Hi-Fi Products
Service Bulletin

Model: CDP-C201/C205/C215/C225/C27/C305/C315/
C322M/C35/C37/C400/C401/C500/C515/C700/
C705/C715/C75ES/C8ESD/C800/C85ES,
SEN-301CD/311CD/501

No. 244R1

Subject: Part Change: Disc Table

DISC TABLE SECTION

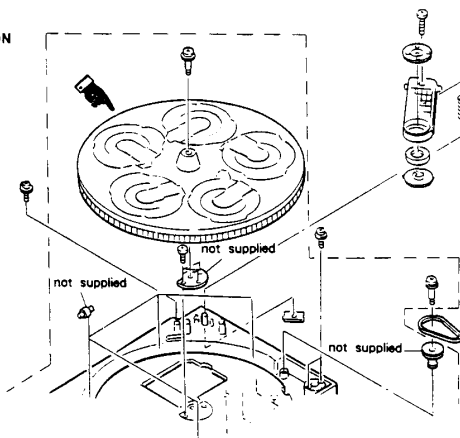
Symptom: (**)
Disc tables supplied by KCP for replacement will be of the 2-hole type instead of the 1-hole type on some models.

Solution: Order the disc table having the desired finish from the chart below. The 2-hole type disc table replaces the 1-hole, 1-slot type disc table.
